FIRE SAFETY INSPECTION REPORT

VANCOT LIMITED

**PLOT 18-20, SECTOR 3, KEPZ, NORTH PATENGA
EPZ THANA, CHITTAGONG**

June 10, 2014

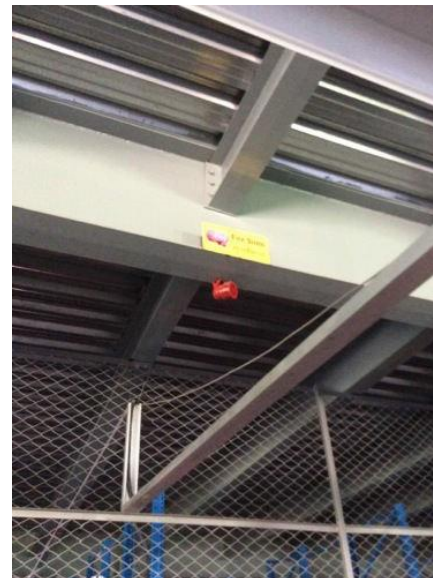
F-8	Egress	Storage was located in the exit stair. On north and south stairs	Remove all storage from exit stairs and egress paths.	Immediate
-----	--------	--	---	-----------
